City of Huron Agenda for the Planning Commission/DRB Wednesday, August 16, 2023 5:00pm.

RE: Sawmill Creek Re-Zoning Public Hearing & Recommendation

FROM: Erik Engle, Planning Director **RE:** Seven Lakeway Refractories

SEVEN LAKEWAY REFRACTORIES PRELIMINARY SITE PLANS

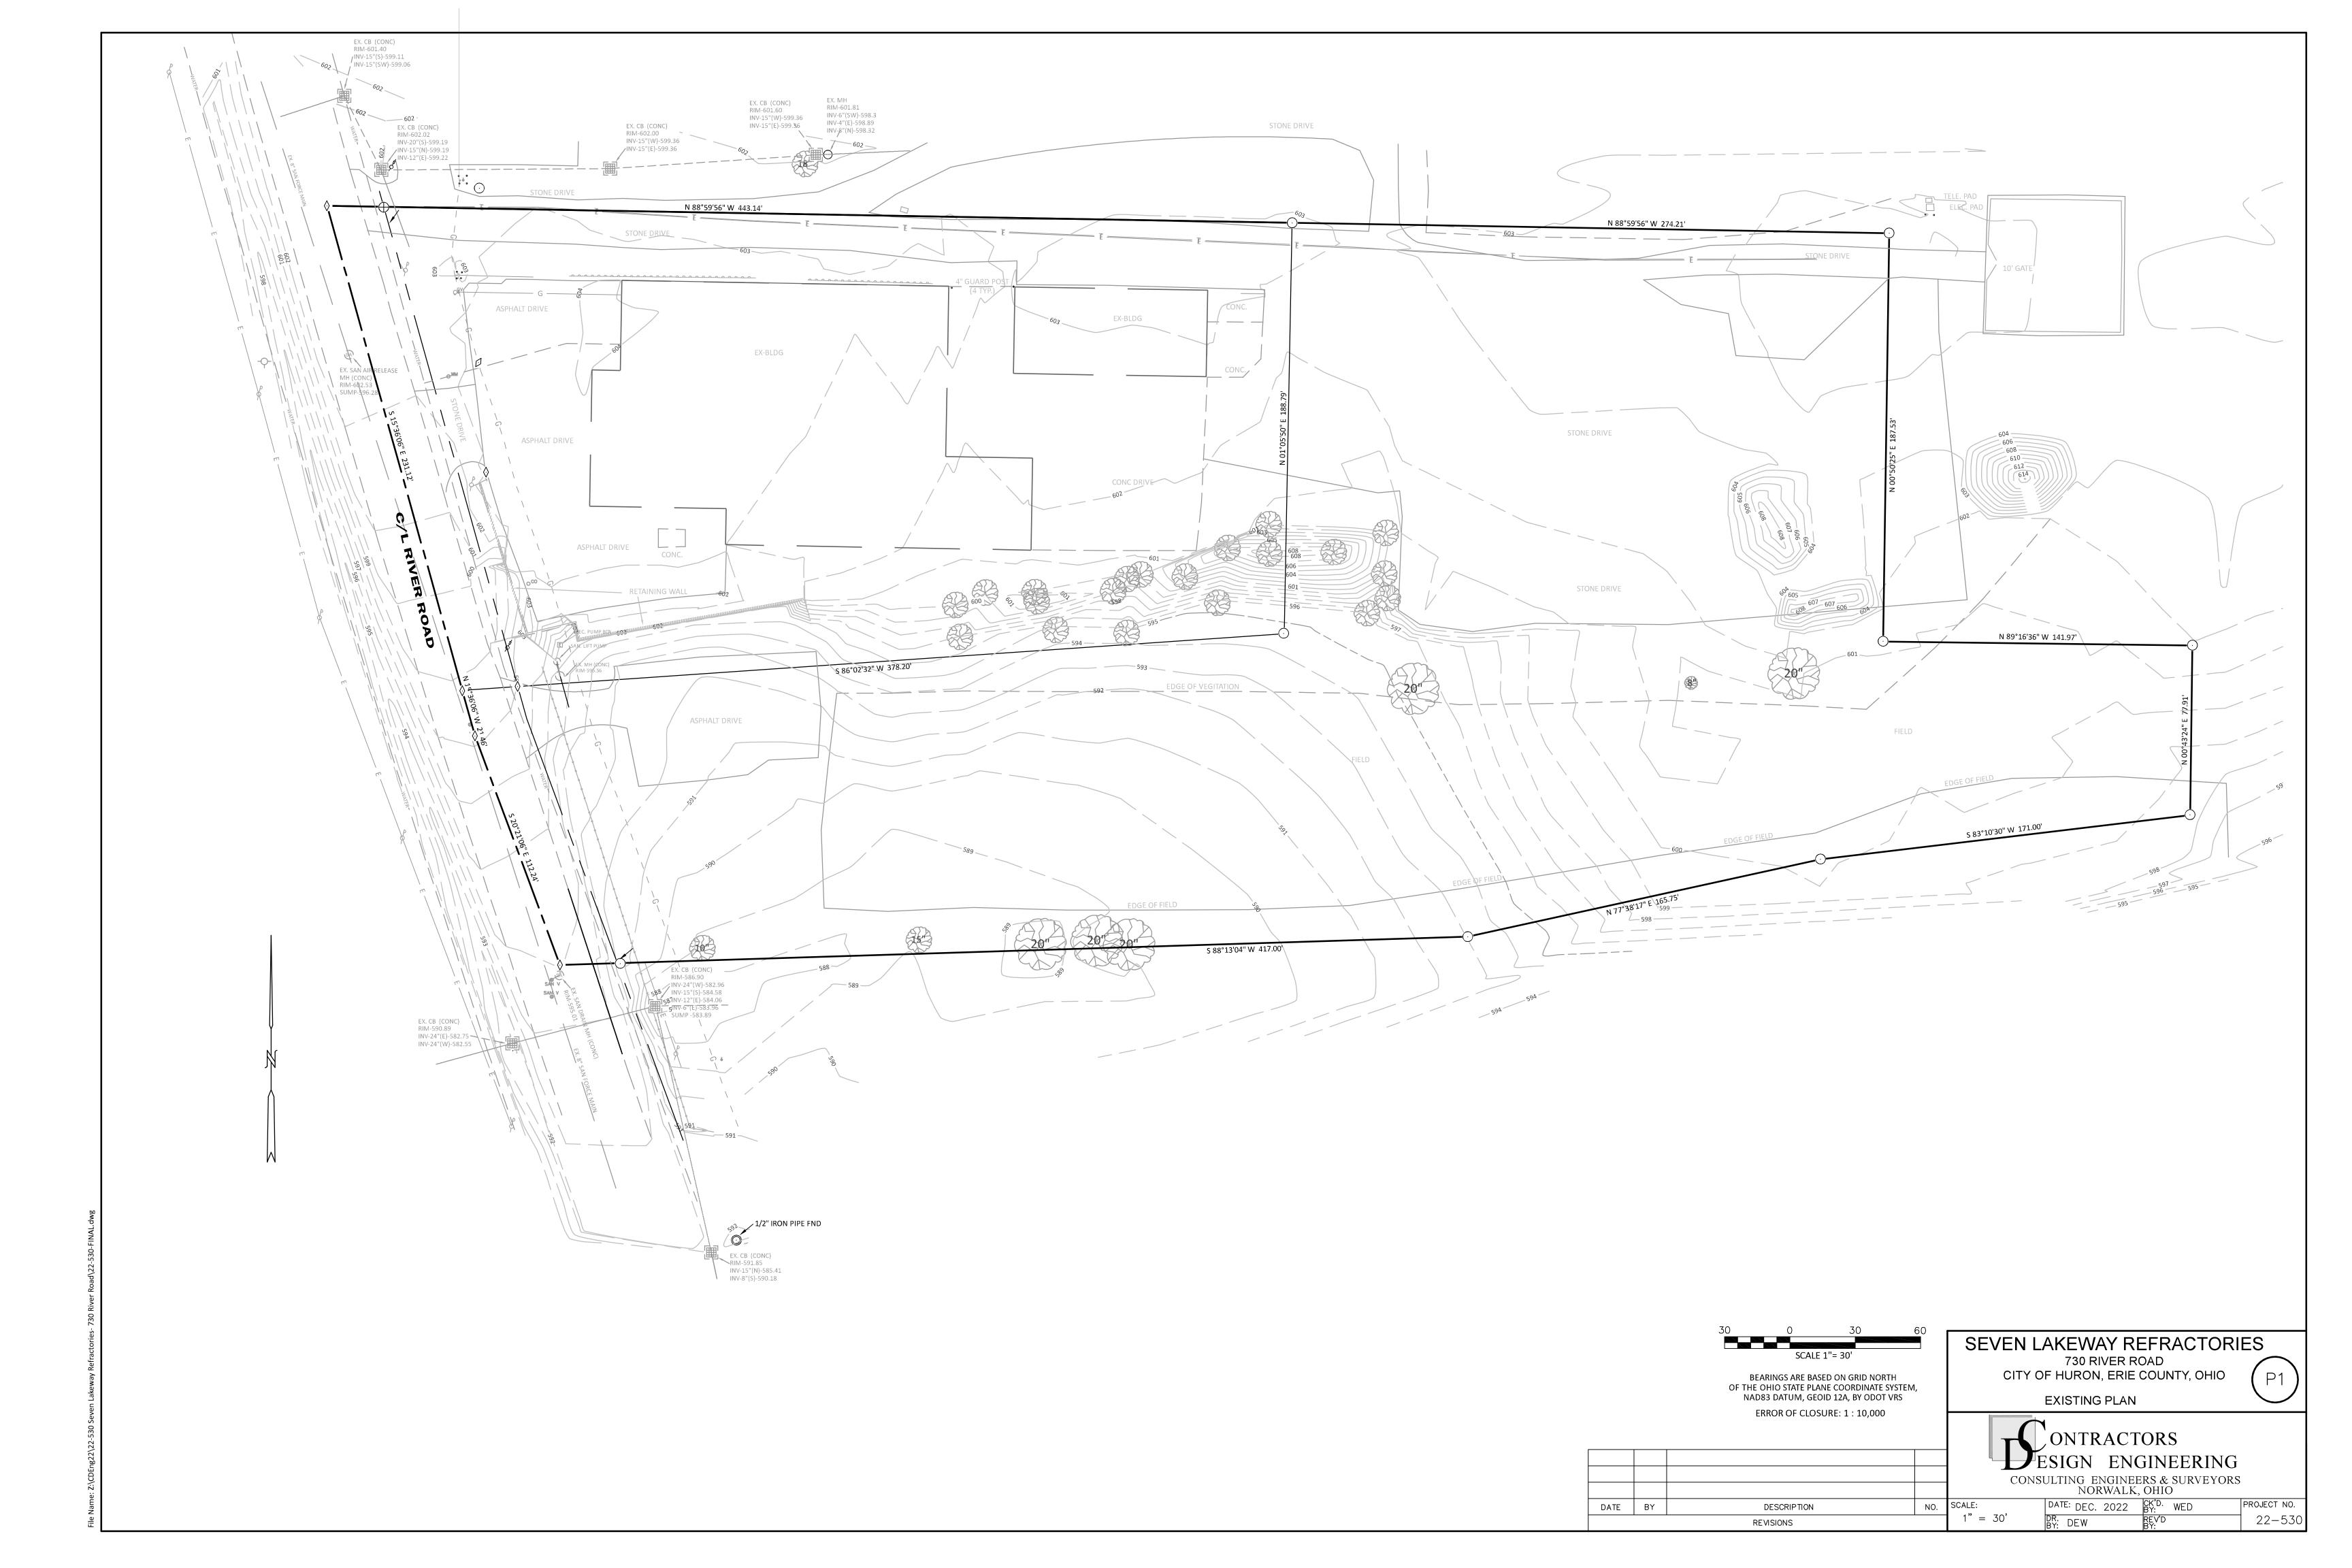
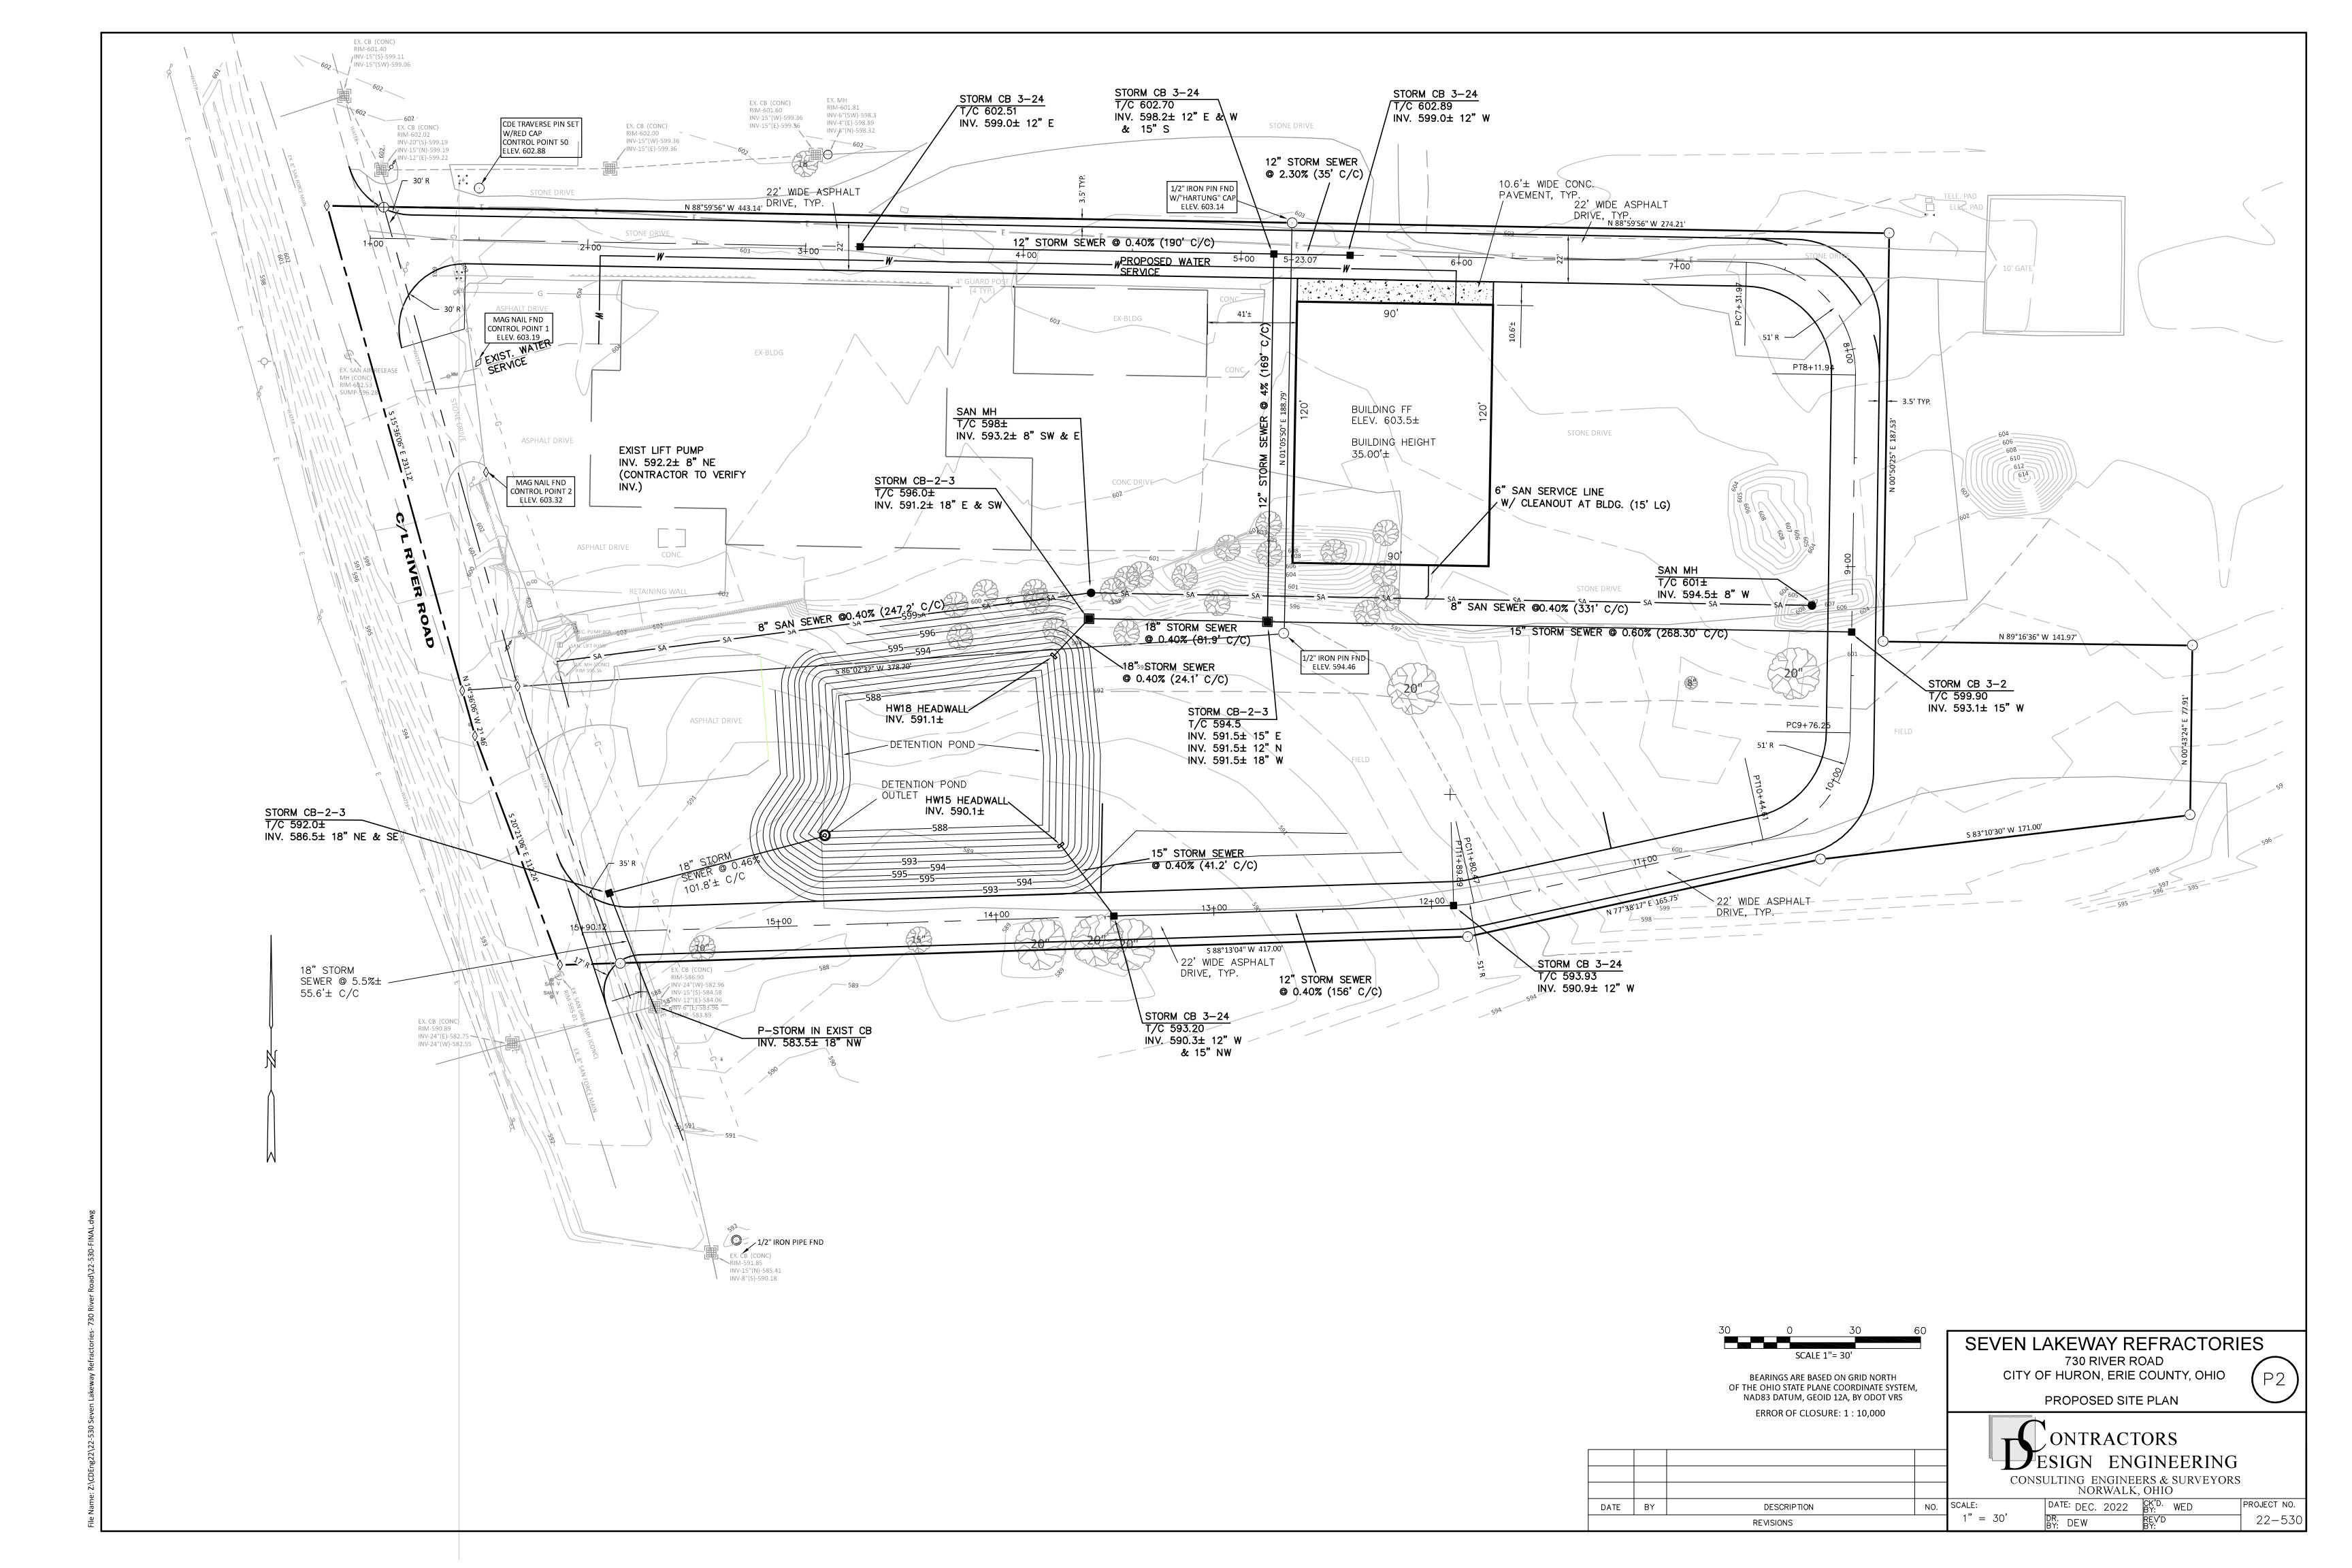
As proposed, the plans include a new 10,800sf warehouse building which meets all site plan regulations for an I-2 Zoning District. The building will be constructed of steel roof and wall panel; proposed wall panel color will be Ash Gray. Exterior lighting includes two wall mounted, shielded, LED fixtures on each side of the building. A landscaping plan has been included.

The landscape plan meets all required standards related to plantings and islands. Perimeter parking lot landscaping shall be incorporated pursuant to 1131.05 along the northwest corner of the front parking lot along River Road.

Stormwater mitigation has been addressed and incorporated into the site plan/design proposal in the form of a detention pond.

The proposed site plan will utilize existing lots with the spaces clearly demarcated. The total number of spaces proposed is 25 parking spaces meeting the 12 required by code. The proposed

site plan will improve ingress/egress of truck trailers by incorporating a paved loop road for deliveries and shipments.

Staff recommends approval of the site plan and design with the following conditions:
